**Loop 303 Corridor/White Tanks
Area Drainage Master Plan Update
Contract FCD 99-40**

**Level II Alternatives
Analysis Report**

Flood Control District of Maricopa County

Comment Responses for Level II Report Phase One – General Comments

FIGURE 2.1
URS

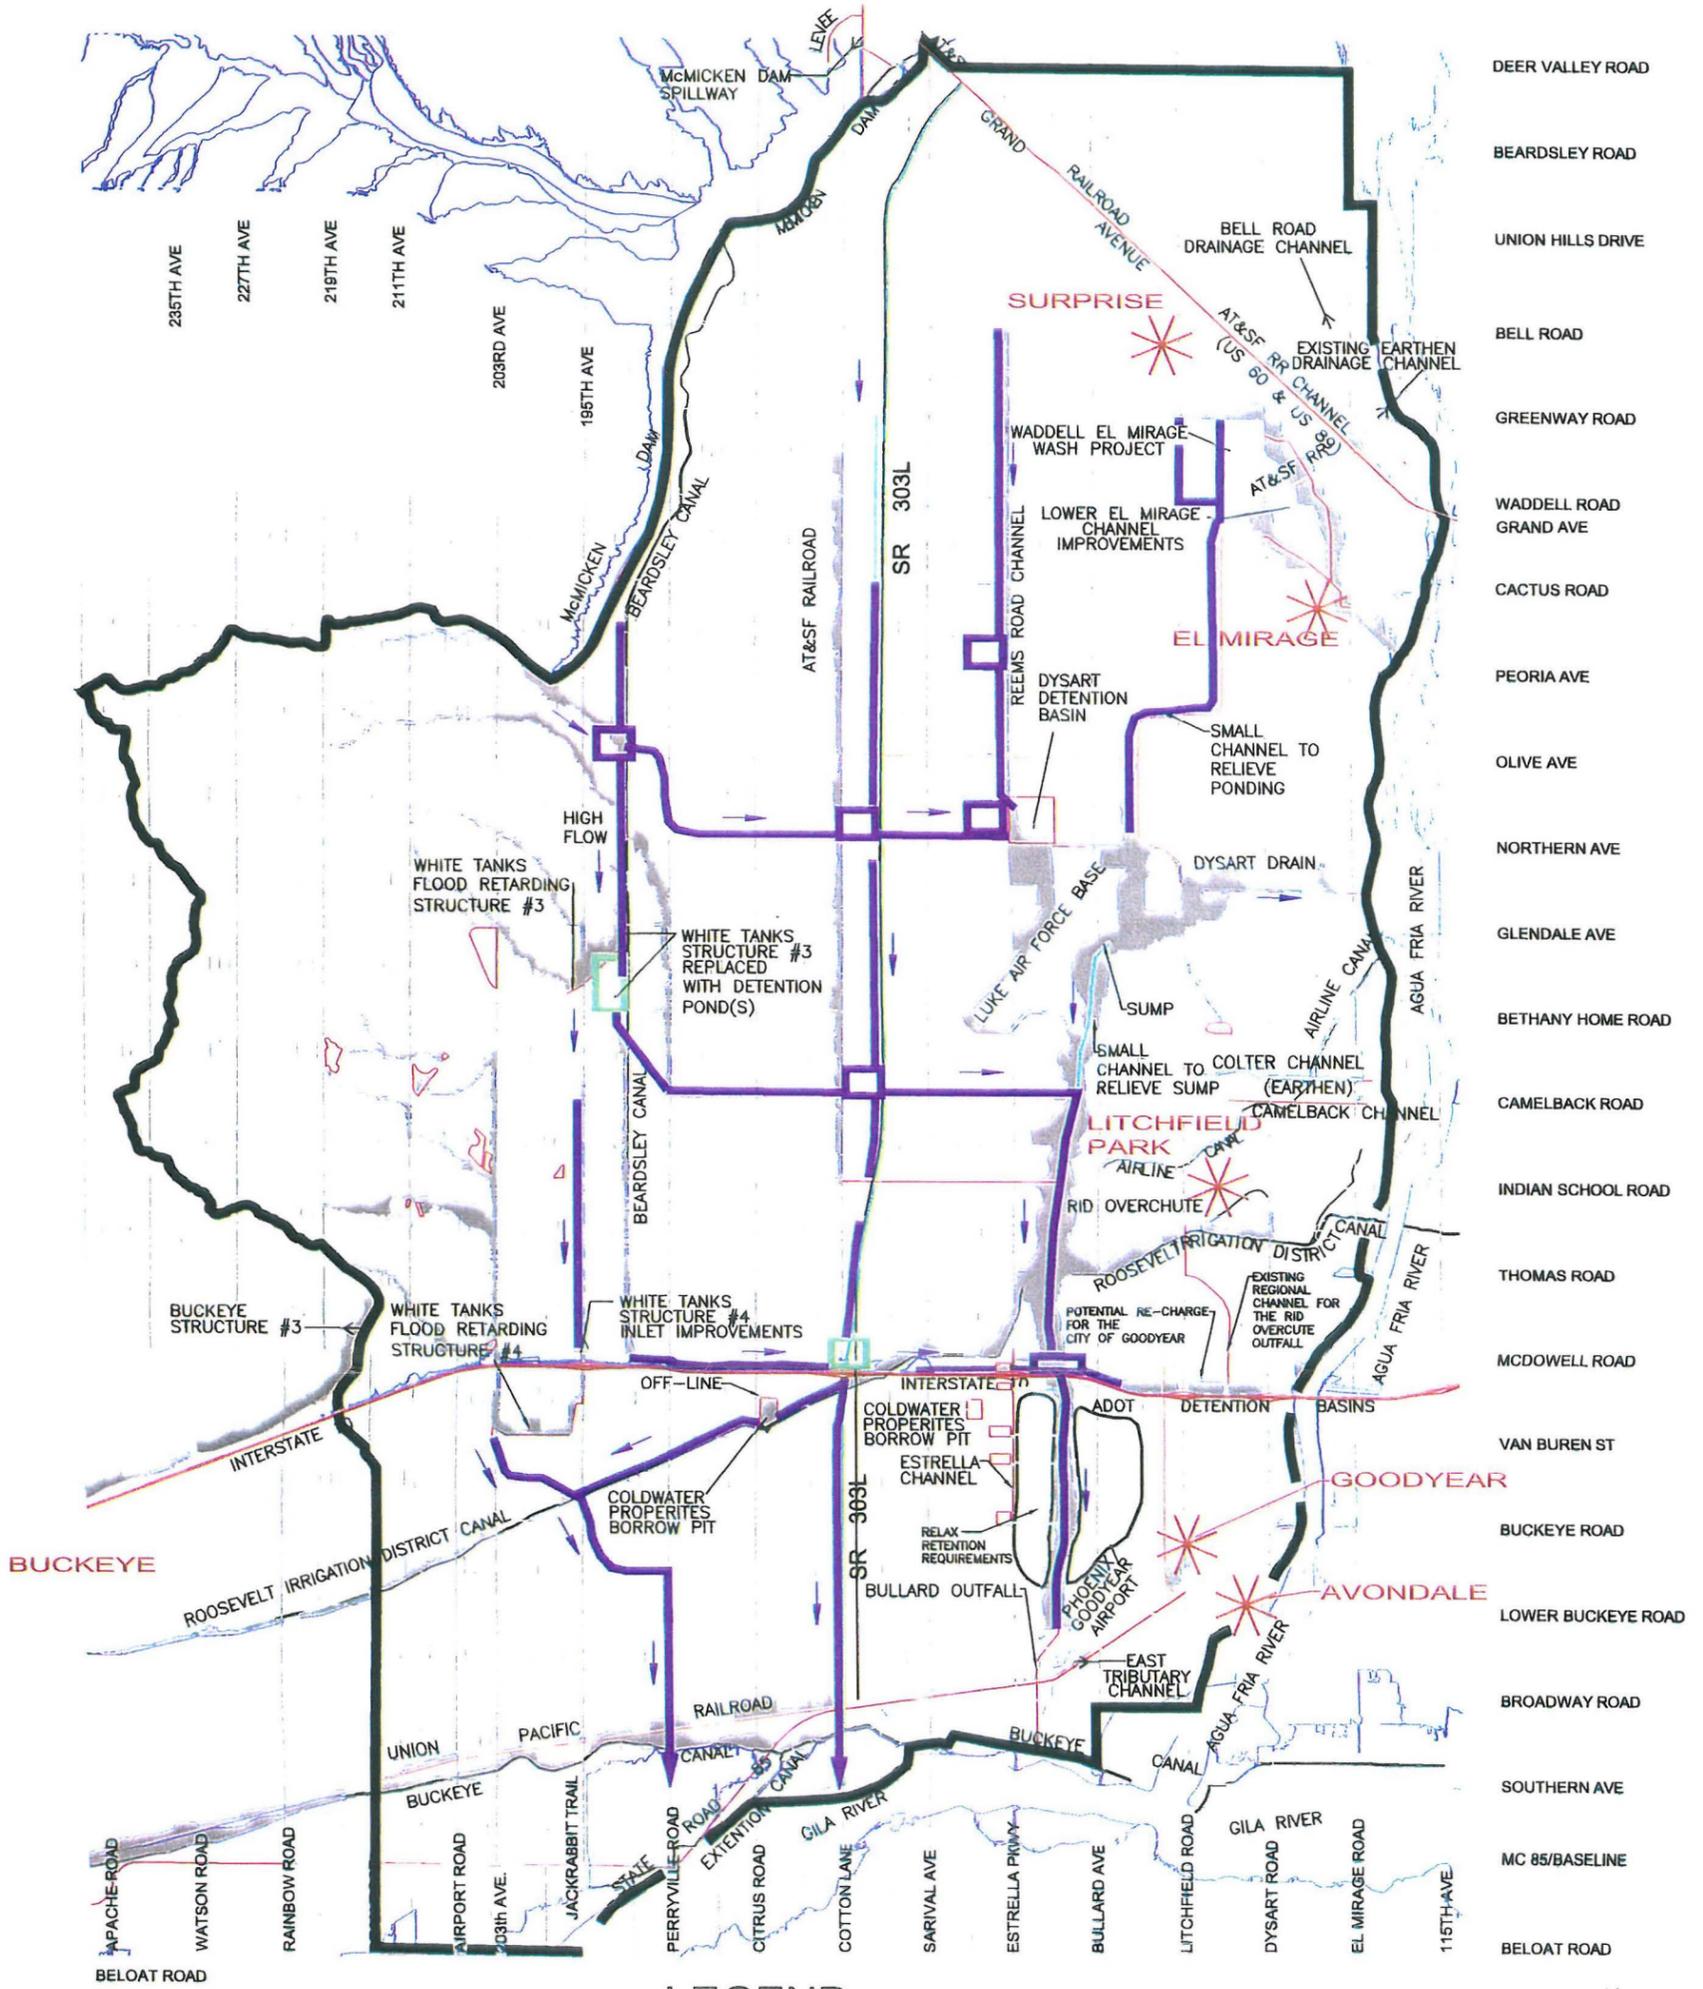
2. **Figure 2.1: Will these be in color for the final submittal?** *All color figures are included in the June 2004 submittal.*
3. **Page 2-5: This date is not correct.** *The date has been corrected to July 19, 2001 for the effective FIRM.*

FIGURE 3.1A

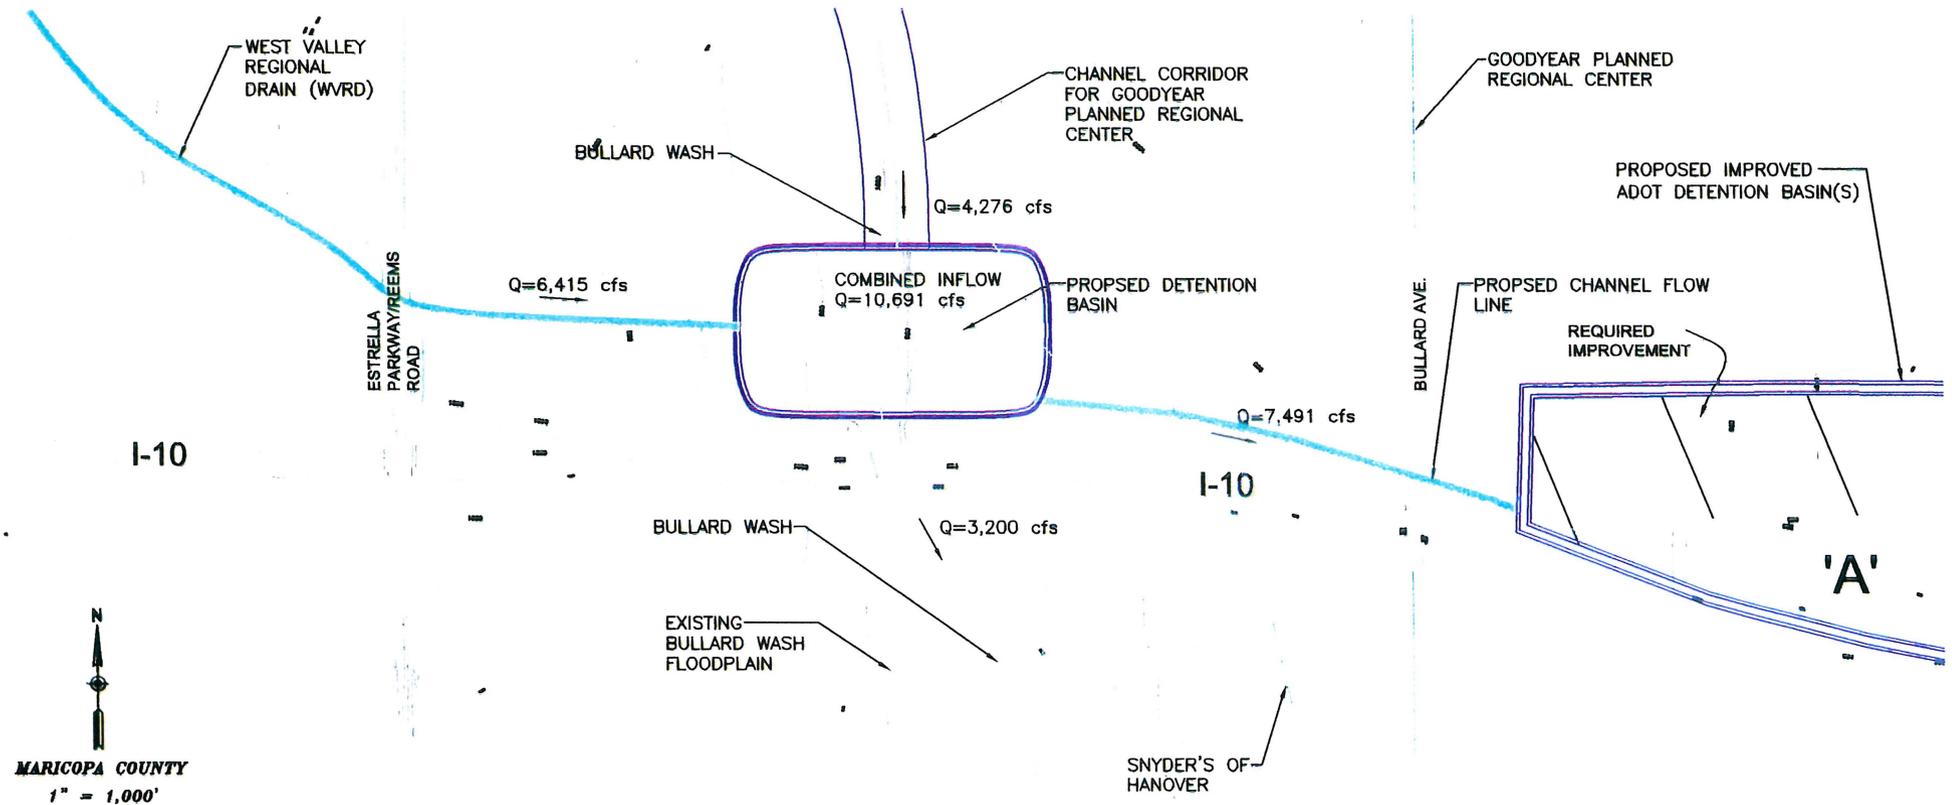
11. **Page 3-5: Syntax**
12. **Page 3-6: Syntax**
13. **Page 3-14: Figure 3.1A calls out a “WVRD” not a “WVRC”, please be consistent.** *Sentence has been corrected to read “West Valley Regional Drain”.*

Figure 2.6

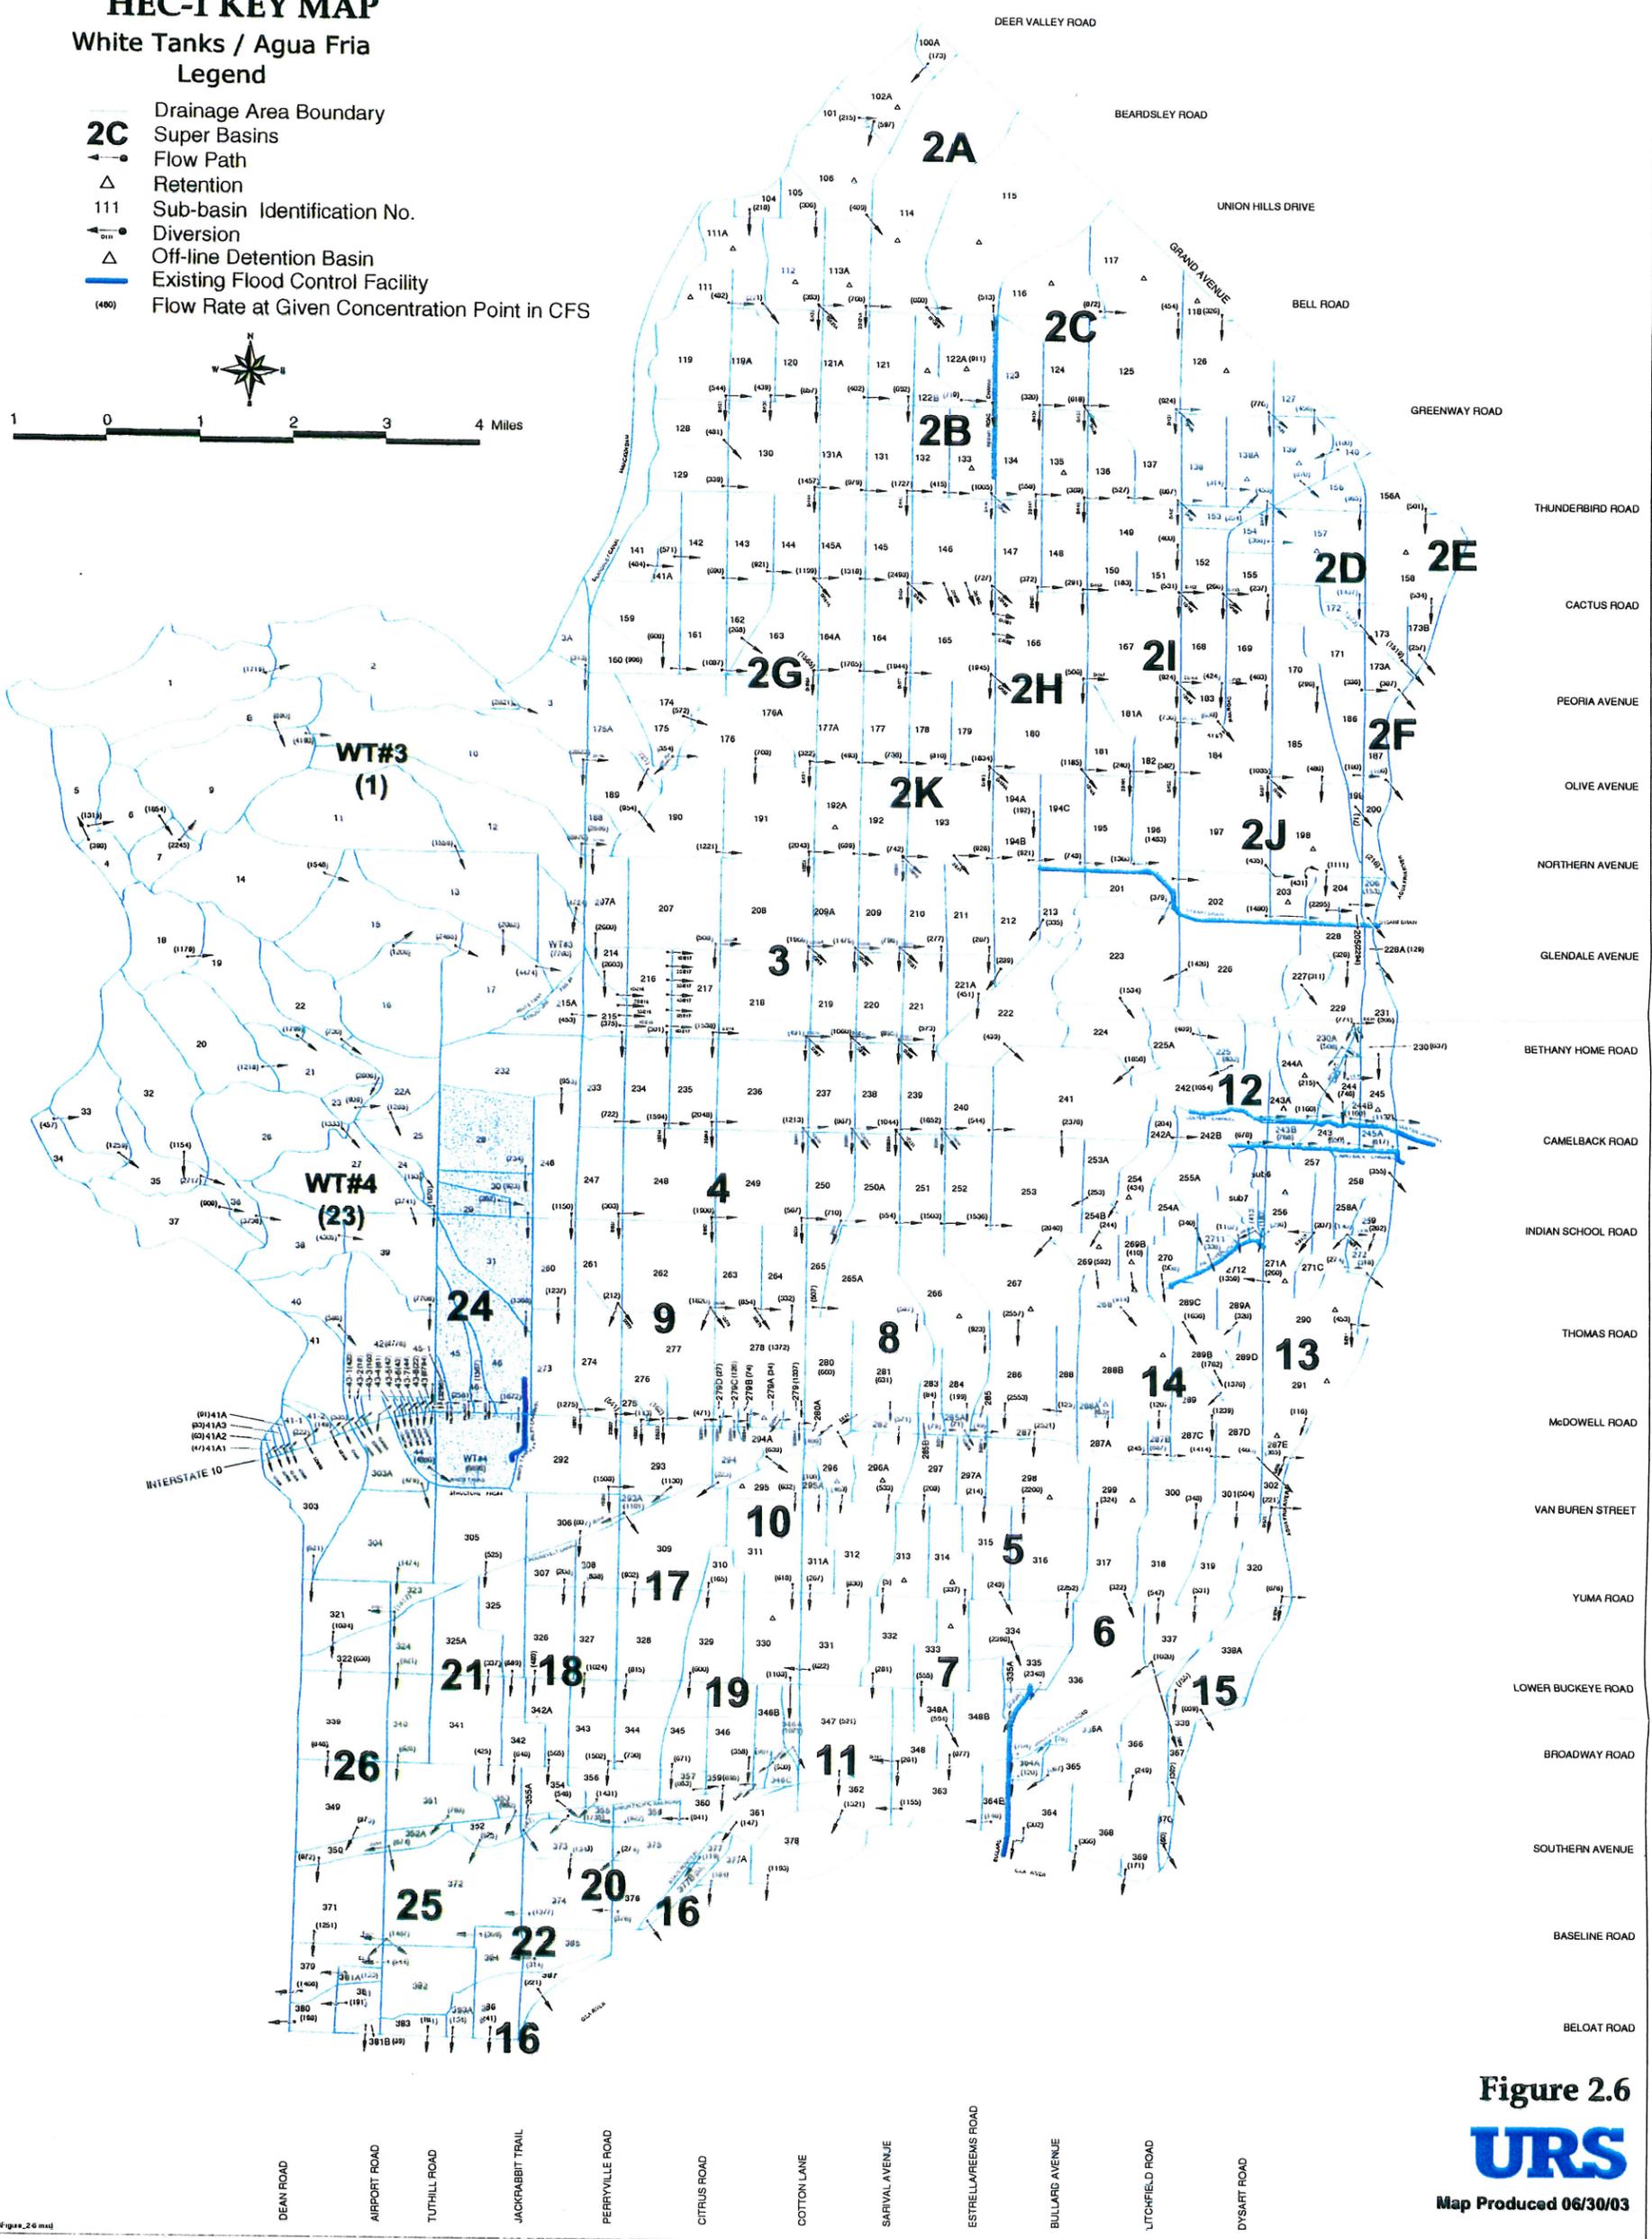
22. **Figure 2.6: Add flow values to figure.** *Map has been modified to show flow values.*
23. **Page 2-30: Is the additional proposed basin just west of the existing Falcon Dunes detention basin needed?** *Recent as-built surveys indicate Falcon Dunes is significantly under capacity, therefore, this basin is needed.*
